**ADDENDUM NO. 1**  
**October 28, 2020**  
**225902**

**RE: TOWN OF JERICHO, VERMONT**  
**JERICHO EWP 5038-007**  
**DRY LAID STONE MASONRY WALL RESCONSTRUCTION**

**FROM: DDK ENGINEERING-JV**  
28 North Main Street  
Randolph, Vermont 05060  
(802) 728-3376

SHEET 6 OF 22

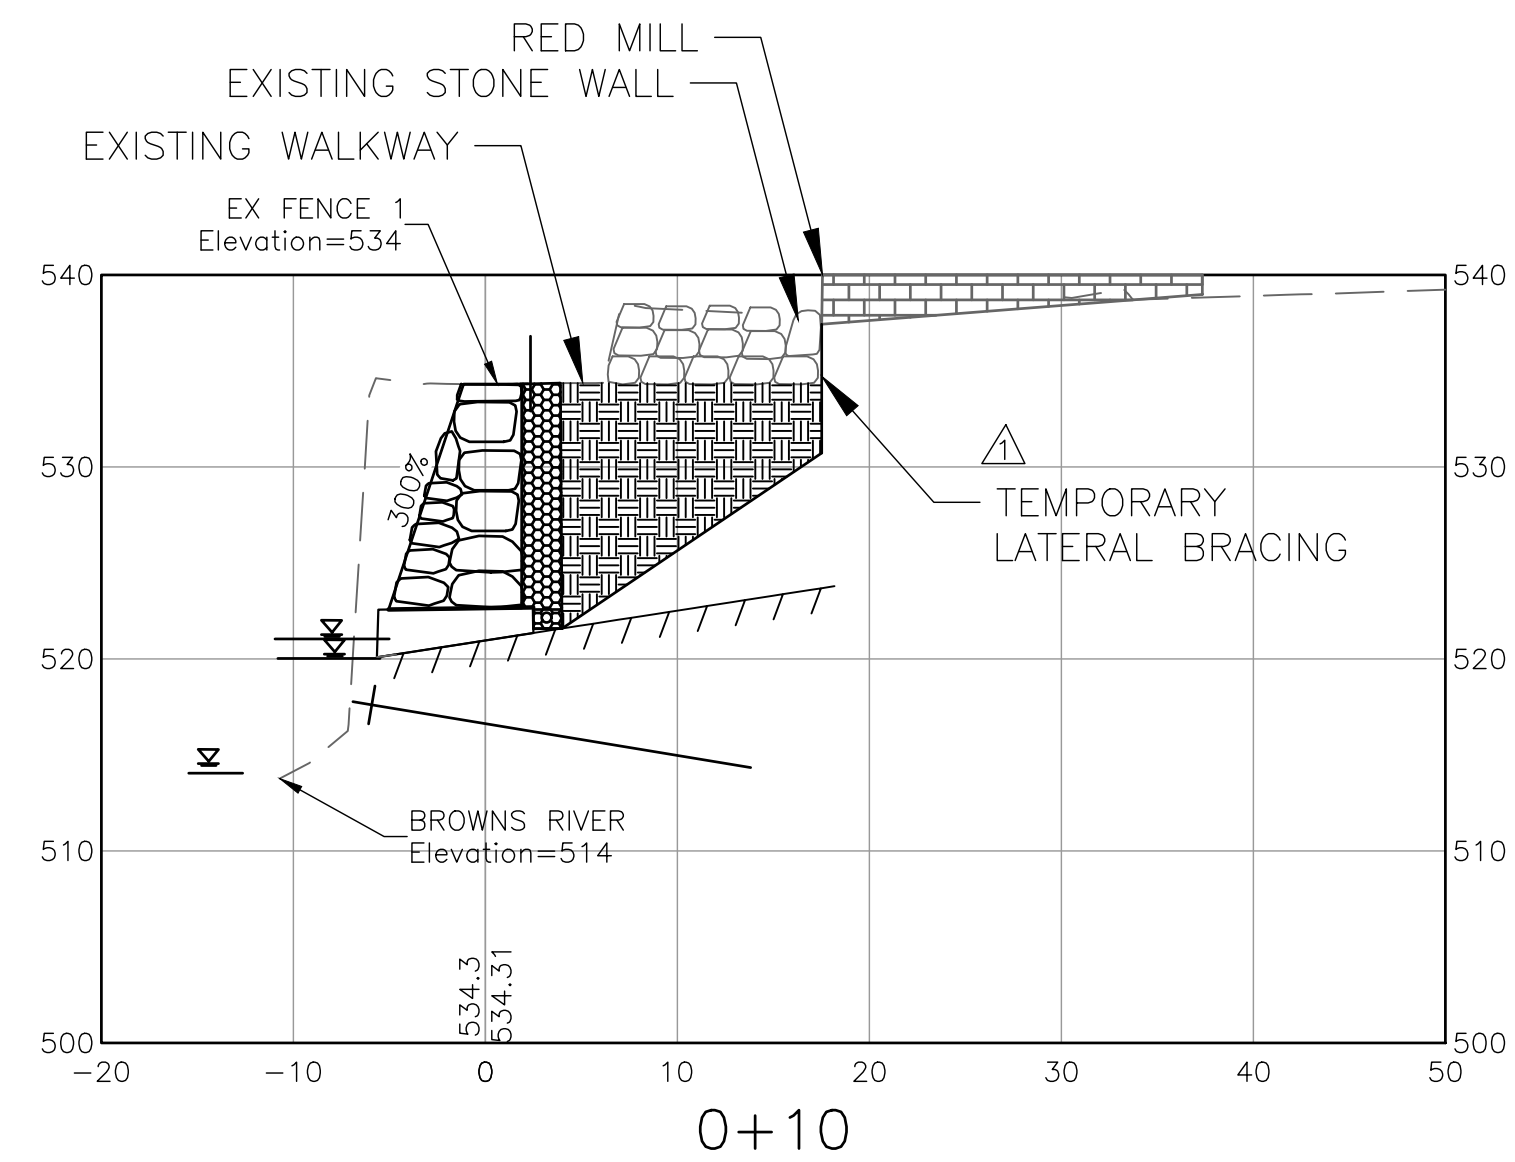
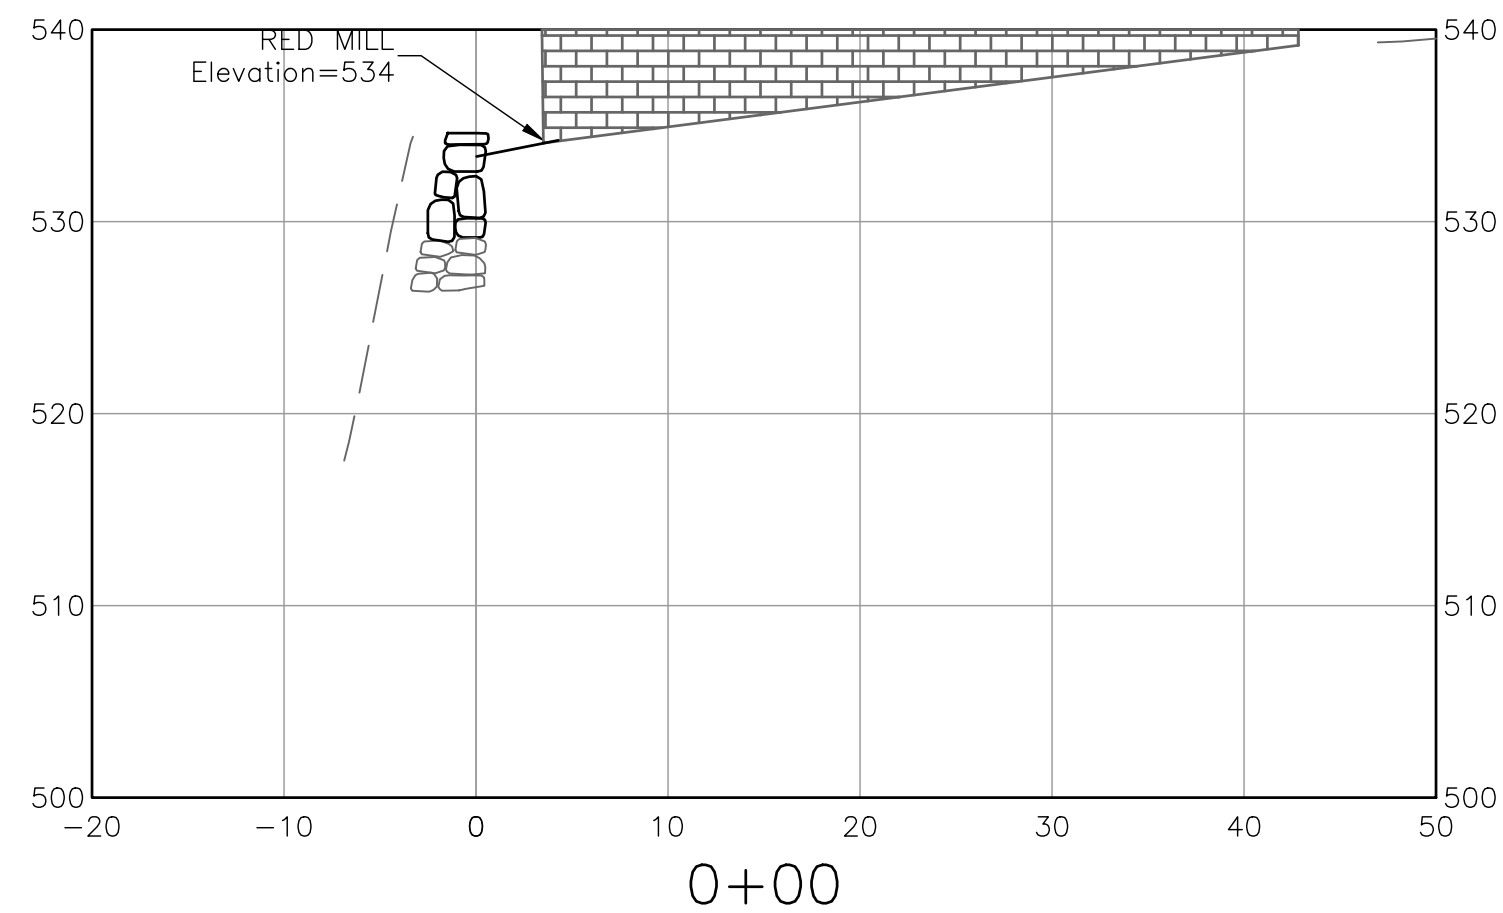
NO.	DATE	DESCRIPTION	BY	CK'D
1	10-27-2020	ROADWORK DETAILS, EXCAVATION LIMITS	KMF	GPH
